DA-2023/760/ PPSTH-306 –22-30 Kenny Street, Wollongong

Panel Reference	PPSSTH-306
DA Number	DA-2023/760
LGA	Wollongong City Council
Proposed Development	Mixed use development - demolition of existing structures, tree removal, construction of an 18 storey mixed use building consisting of a hotel with food and drink premises, commercial premises, 107 hotel suites, 105 residential apartments, ground and basement level parking and associated communal open space areas for both the hotel and residential apartments.
Street Address	22-30 Kenny Street, Wollongong
Applicant/Owner	TFR Pty Ltd
Date of DA lodgement	27 September 2023
Total number of Submissions	Three (3)
Number of Unique Objections	First round of notification between 13-27 October 2023 where two (2) submissions were received (including one (1) letter of support). Second round of notification following the submission of revised plans between 29 April – 13 May 2022 and received one (1) further submission.

N/A <b>s4.15 (1)(a)(iv) the regulations</b> Clause 61 Demolition
List all documents submitted with this report for the Panel's consideration	<b>Attachments</b> <ol style="list-style-type: none"> <li>1. Full set of architectural

**Figure 7:** Overshadowing impacts in midwinter

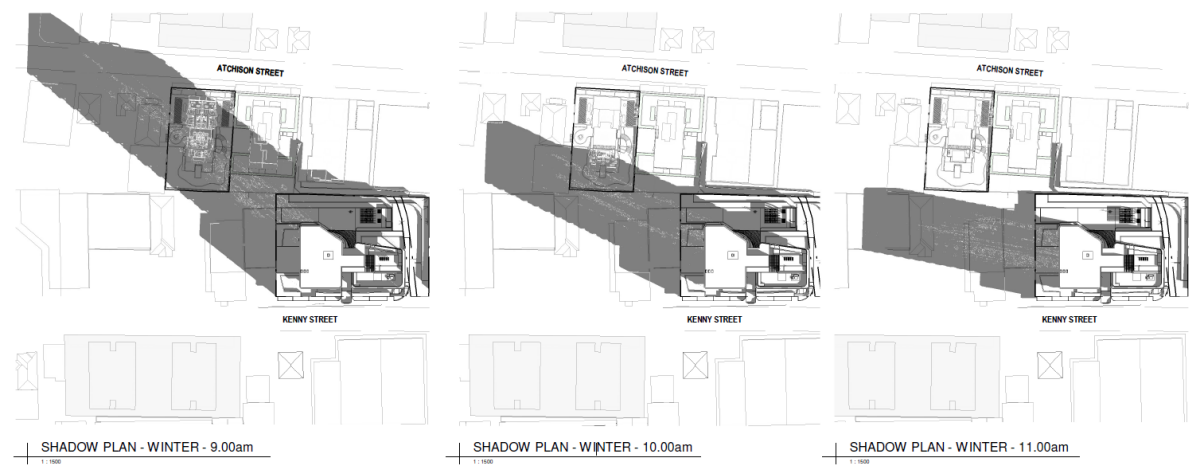
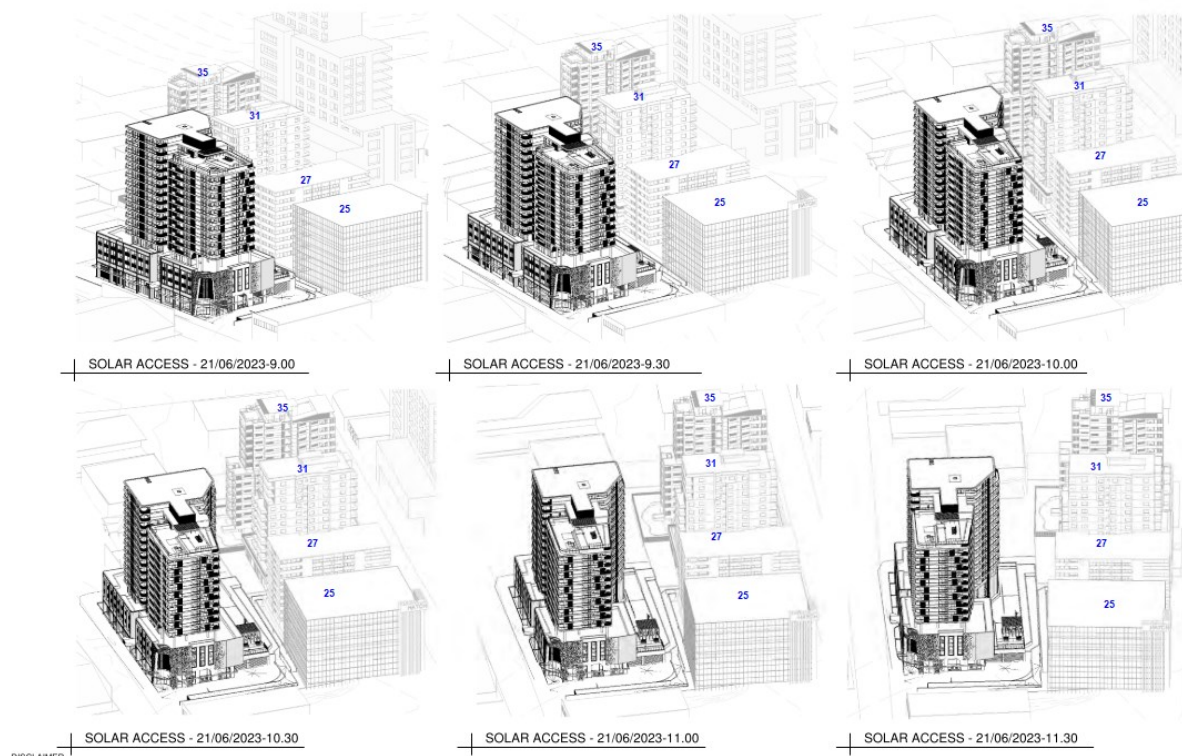
The applicant's shadow diagrams are included in full as part of **Attachment 1**. The plans indicate that the adjoining shop top housing developments to the west of the site at 27 and 31 Atchison Street and 35 Atchison Street further south will be overshadowed in the mornings in midwinter (i.e. when the worst overshadowing impacts occur):

The sun-eye view diagrams indicate that overshadowing will impact east facing units at 27, 31 and 35 Atchison Street at 9am. By 9:30am there are no impacts to 27 Atchison Street, however 31 and 35 Atchison Street are still partly overshadowed. Windows to living areas will receive sunlight at 9:30 to 31 Atchison Street. By 10am, solar access to 31 Atchison Street is not overshadowed by the development and solar access is available to the majority of rear units at 35 Atchison Street noting they have living room windows facing north.

The shadowing impacts on the childcare centre at 31 Atchison Street indicate that from 10am, solar access is available (as shown above).

These buildings have units oriented to the west and to the east to receive either morning or afternoon sunlight access, as they are all overshadowed by the existing buildings to their north. In the city centre context sunlight access is more difficult to protect where the planning controls anticipate large buildings. Substantial changes to the proposed building would be required to remove overshadowing impacts entirely. Significant design changes have been made following Council and DRP comments, namely the chamfering of the northern tower which results in a more site responsive design that lessens the overshadowing impacts when compared to the original design. Given the building is consistent with the form of development and the building envelope largely anticipated by the planning controls for the site, requiring further design changes is not warranted.

**Figure 8:** Site plan showing the position of the proposed tower in relation to Atchison Street neighbouring buildings

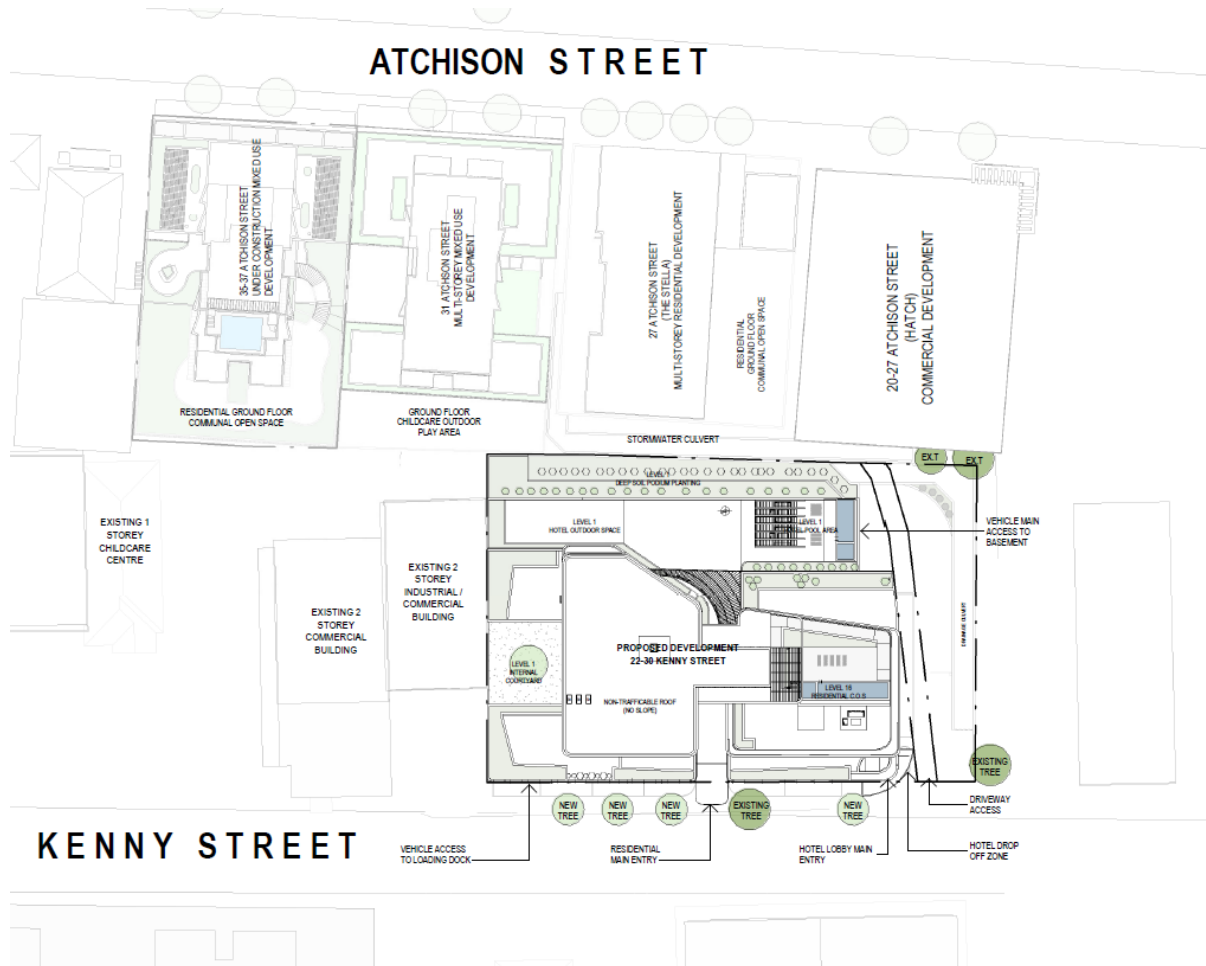
The most affected views will be from the east facing units at 27 Atchison Street as the positioning of the building aligns with the proposed tower, as shown below:

The proposed development will obstruct existing easterly views from 27 Atchison Street, with direct eastern views being blocked by the position of the tower as indicated by Figure 8 above. Existing views through the 12m side setbacks and partial views through the double height communal open space on Level 4 will be possible from some of these units. The chamfering of the northern part of the tower will facilitate some view sharing to the north-east.

On balance the view impacts are acceptable.

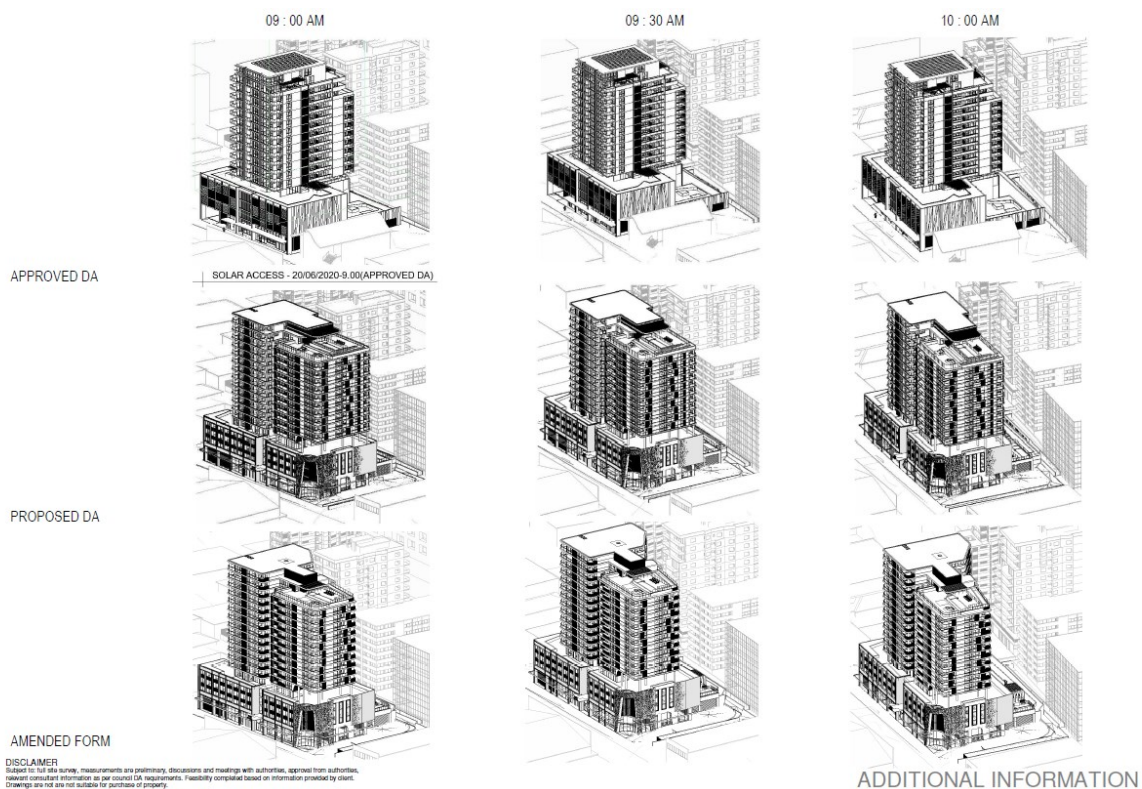
1. *The DRP commented on the lack of detail provided for the potential future built forms of neighbouring developments, with focus on the site immediately to the south, and how the proposal related to the future forms. Additional streetscape elevations and axonometric views (drawing numbers 05 to 08) were provided by the applicant, demonstrating how the future built forms including podium levels interface with the proposal in the broader streetscape. The additional drawings show how the podium could be continued at the street boundary towards Ellen St, and how ADG-compliant amenity objectives would be allowed to the neighbouring sites. No further issues have been noted. The provided information is considered sufficient and satisfies the concerns raised.*

2. *Solar access to the neighbouring developments (both existing and potential future forms) was noted by the DRP as a key concern. This included to residential units, as well as to the neighbouring childcare centre to the south-west of the site. The applicant submitted a significantly amended design following the DRP meeting of 10 November 2023, which included more sculptural and tapered tower forms. The amended tower design narrowed the northern portion of the tower, and tapered the wider southern portion of the tower, to allow greater solar access to the neighbouring developments to the south and west (refer to drawing 096 to 098 for comparisons). This is a significant design improvement and is welcomed and resolves the concerns.*

3. *The DRP commented on the entrance and access arrangements to the lobbies and hotel spaces, including the door spacing, access ramps, paths of travel, amount of steps, and flood response at the commercial frontage. The resubmitted application provided very minor amendments to doors and ramps only. In discussion with Council's flood engineers the commercial tenancy could not extend over the service entrance driveway - which was to remain clear for overland flow conditions. The amended proposal has therefore not captured all DRP recommendations however, it has allowed suitably functional and compliant paths of access to the building, and a resolved flooding response.*

FIGURE 10 GROUND LEVEL CONTEXT ANALYSIS (DWA)

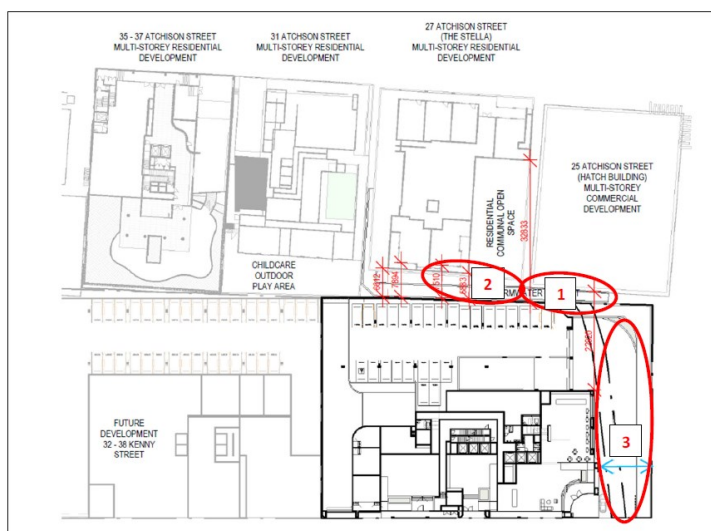
In relation to development departure 1 indicated above, the proposed building is built to the rear boundary. Clause 8.6(2(a)) requires a zero/0m development standard which cannot be achieved as the neighbouring building is setback from its rear boundary by ~3.5m.

FIGURE 10 GROUND LEVEL CONTEXT ANALYSIS (DWA)

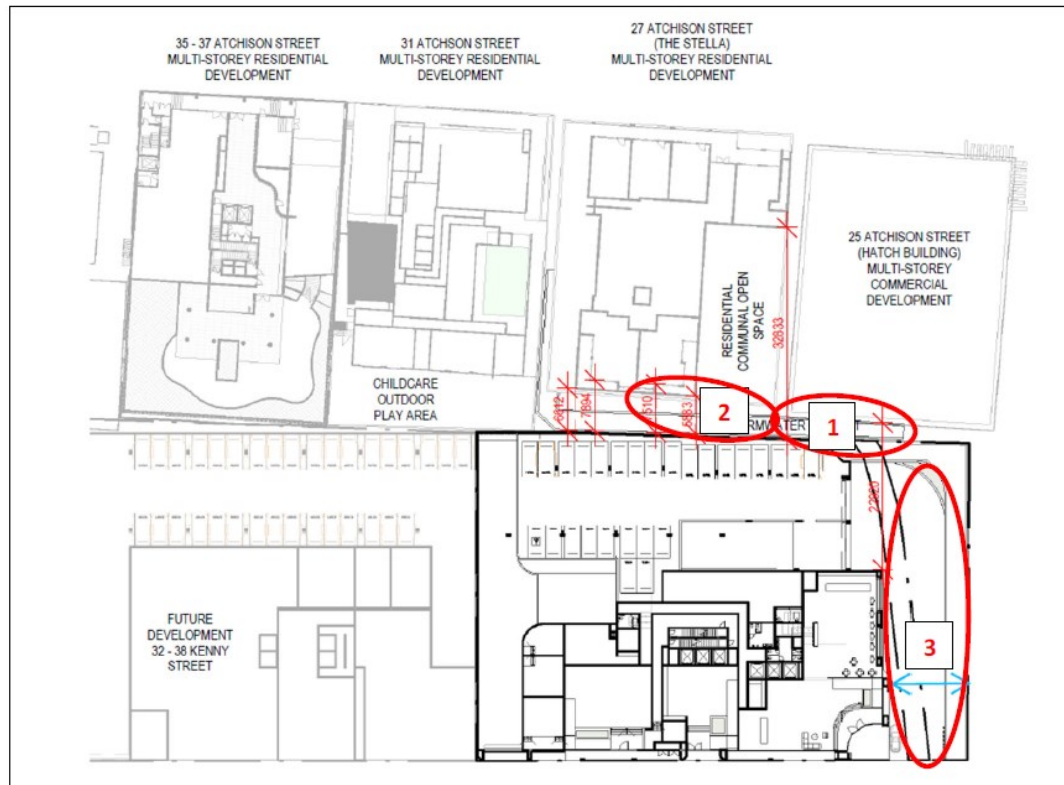
1. the ground level setback under subclause 2(a) requires a zero/0m setback where a 3.5m distance is proposed to the west which is a commercial building at 25 Atchison Street; and
2. the ground level setback under subclause 2(a) requires a zero/0m setback where a 12m northern boundary setback is proposed due to the drainage easement; and
3. the ground and first floor setbacks under subclause 3(b) requires a 16m setback where a 5.883m distance is proposed to the residential flat building at 27 Atchison Street (63% variation).

In relation to subclause 2(a) the building is built to the southern site boundary, however, cannot be built to the northern boundary to achieve the 0m separation as this portion of the site is burdened by a drainage easement and is an overland flood path. The clause 4.6 statement addresses this development departure.

**Figure 10:** Ground level separation distances to the western/rear boundary

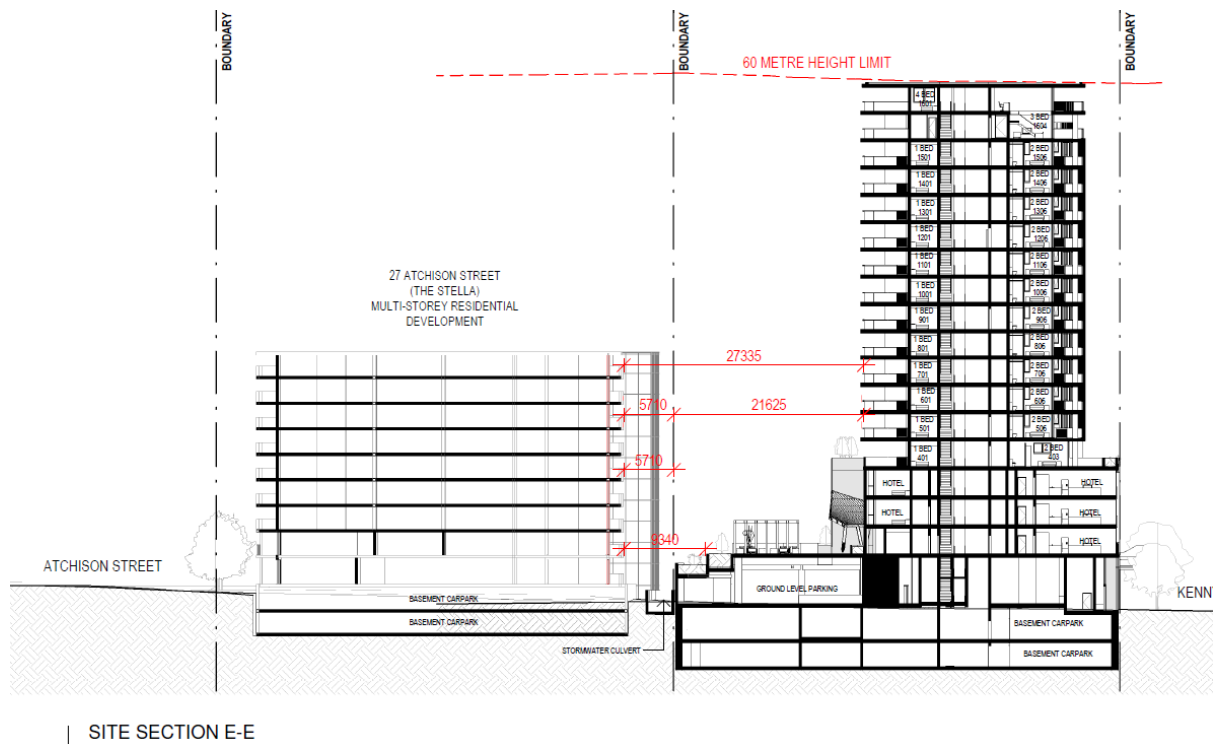
The ground floor and Level 1 podium is built up to the rear (western) boundary for the majority of this boundary which is typical of a commercial building. However to provide an appropriate interface with the adjoining residential buildings the podium has been stepped back with landscaped planters to minimise the visual impact as viewed from 27 and 31 Atchison Street as shown below:
